SRI VENKATESWARA TEMPLE – SP 10-18

PLAN REVIEW CENTER REPORT

Sri Venkateswara Temple and Cultural Center
SP #10-18 with ZCM #10-20

Revised Phasing Plan and Phased Elevations; 3-Phase Development

PHASE A - EAST FACADE

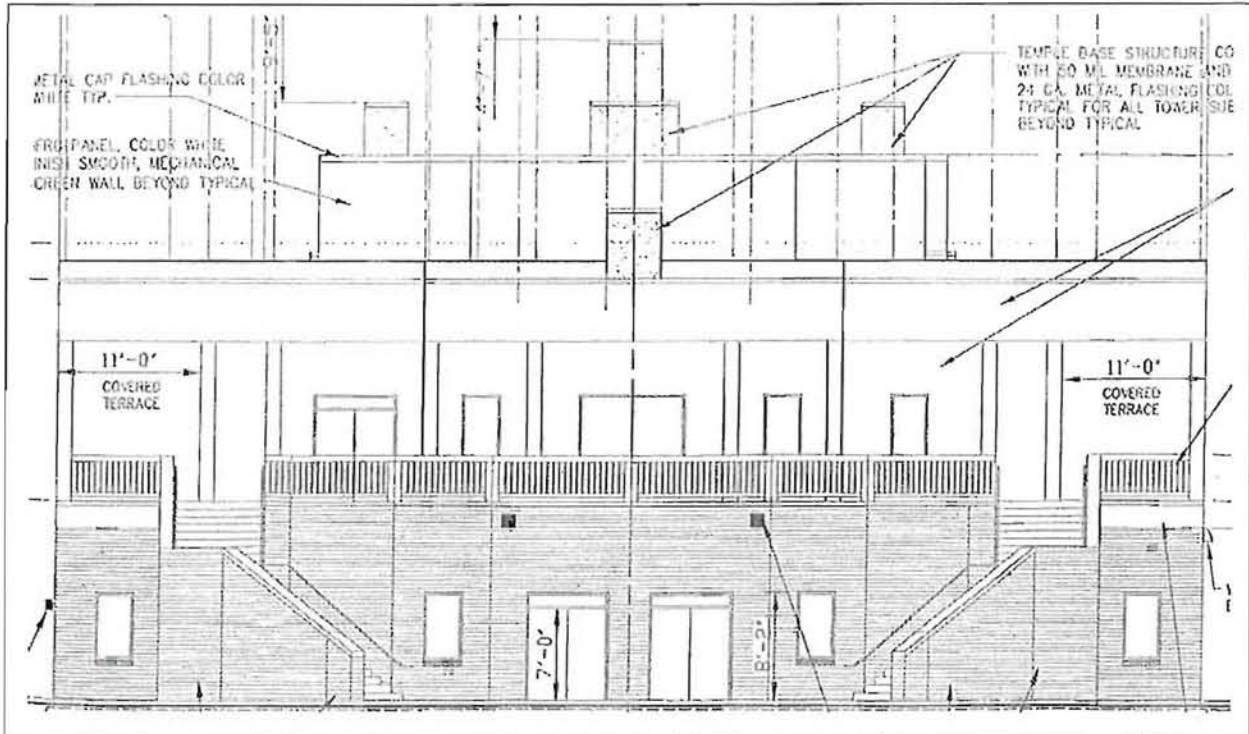
As shown in the above table the percentage of GFRC and Exposed EPDM exceeds the maximum percentages allowed by the Facade Chart for Phase A, and the percentage of GFRC exceeds the maximum percentages allowed by the Facade Chart for Phases B and C.

Recommendation: For the reasons stated above we are unable to make a favorable recommendation for a Section 9 Waiver for the proposed Facade Phases A or B.

Our proposal of the phasing of the elevations is not about the elimination of any detail, it is more about the means and methods that we are proposing to achieve the detail that was presented earlier, and now represented as our Phase C. The justification for the original Section 9 Waiver may only be eliminated if this proposal was asking for permission to conclude and modify the project at Phase A or Phase B only. The fact that we have Phase C as part and parcel of this proposal should leave no doubt that the Owner has every intent and desire to build Phase C. We are not aware of any letters dated 4/25/10 by us, however, we have indicated in our letter of 3/25/10 that Phase B would be continuing as soon as the first Contractor is completed with Phase A. Phase B does consist primarily of the development of the detail on the gopurams (towers) located above the roof line.

What we are presenting in the elevations is only a slight modification which is meant to increase our compliance with the City of Novi Façade Ordinance through our increased use of brick. You may note that in our approved submission packet, the façade review which was dated May 18, 2009 was an analysis of the entire project as a whole in making a determination. The current review is focusing on one specific aspect of the project and is separating the Phases. Therefore we understand that the numbers will be different, however this will not make for a fair comparison against the original approval. If you were to factor the new number to the original approved analysis, you will indeed find that the percentage of brick material has increased and the percentage of GFRC material has indeed decreased making the project more favorable per the City's façade requirements. We are still requesting for the approved Section 9 Waiver, however we are asking for it with increased compliance of the façade ordinance, not decreased.

PHASE C - EAST FACADE

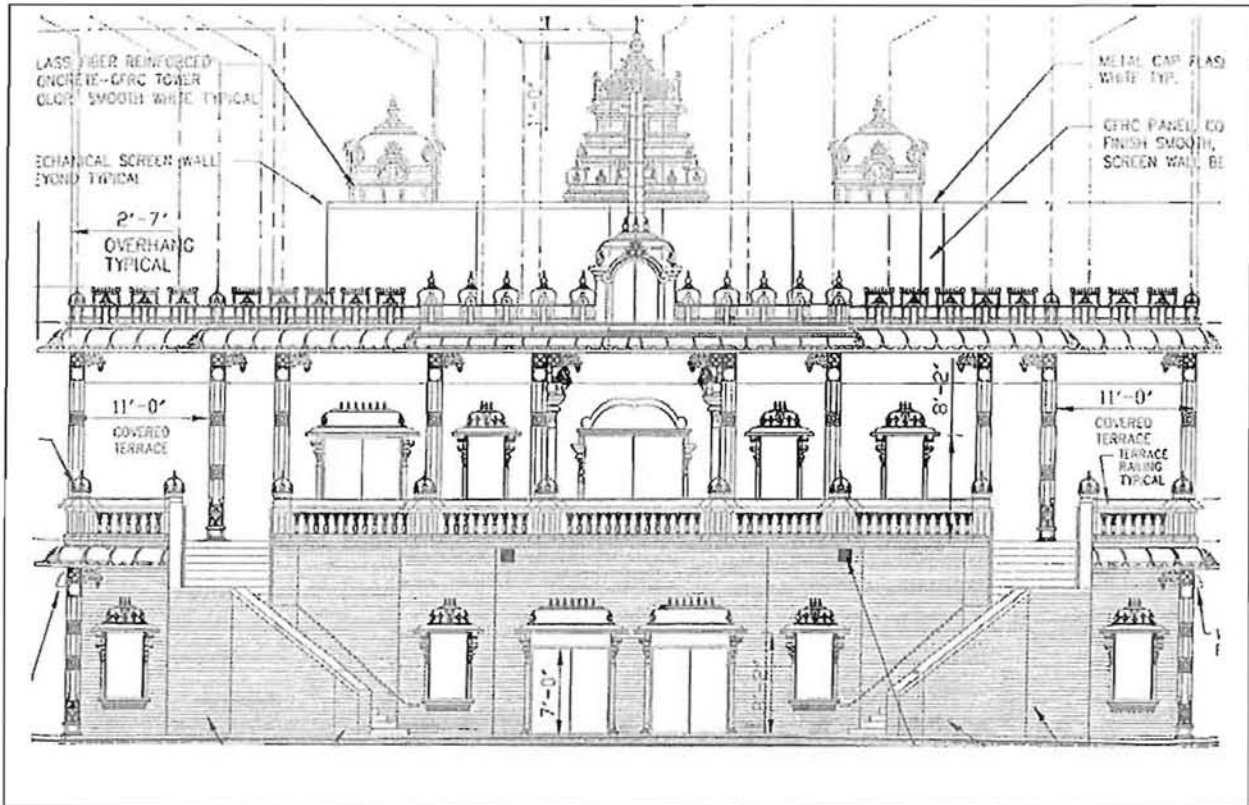
Construction of Facade Phase C appears to be generally consistent with the previously granted Section 9 Waiver. However, no definitive time frame is provided for Phase C leaving the possibility that due to factors beyond anyone's control the Phase C work may not occur for a significant period of time. Similarly, the applicant has indicated that the gateway tower structure (Rajagopuram) will be included in Phase III and that this phase will be completed shortly after Phase I. The Rajagopuram is a stand-alone structure located directly in front of the Temple that significantly adds to the appearance of the building.

The applicant should clarify the timeframe for Phase III (Rajagopuram) as well as facade Phases A, B and C.

Factors beyond anyone’s control can happen at anytime to anything. The same argument can be made without the proposed phases in that during construction, factors beyond anyone’s control

happened to not allow the completion of the originally planned building for a significant period of time.

ORIGINAL EAST FACADE (Basis for prior Section 9 Waiver)

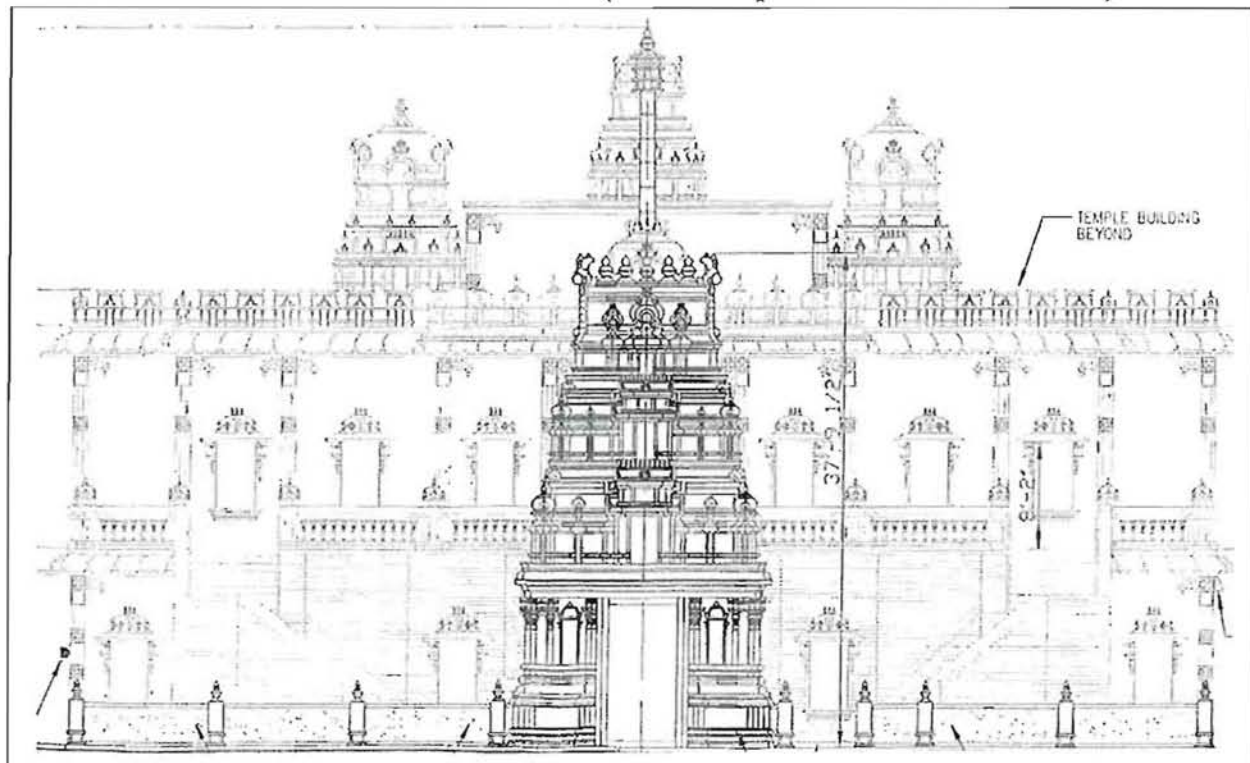
Comments: This project was previously granted a Section 9 Waiver for the use of GFRC. At that time our favorable recommendation for the waiver was substantially based on the unique ability of GFRC to achieve the ornamental details necessary for a traditional Hindu Temple. The proposed facades for Phase A consist of the elimination of all such ornamentation. Unfortunately, this also eliminates the justification for the original Section 9 Waiver. The applicant has stated in his letter dated 4/25/10 that Phase B is intended to commence immediately after Phase A is completed. However, phase B consists primarily of the addition of shikers located above the roof line. This does not affect the lower portion of the structure where the GFRC material is primarily used. The use of GFRS without ornamentation in this manner is not consistent with the intent and purpose of the Facade Ordinance. The proposed white colored EPDM is not allowed in any percentage by the Facade Chart, is not intended as a finish material, and even if used for only a short time will be quite unsightly. No definitive time frames are given for Phases I, II, III, or Facade Phases A, B or C.
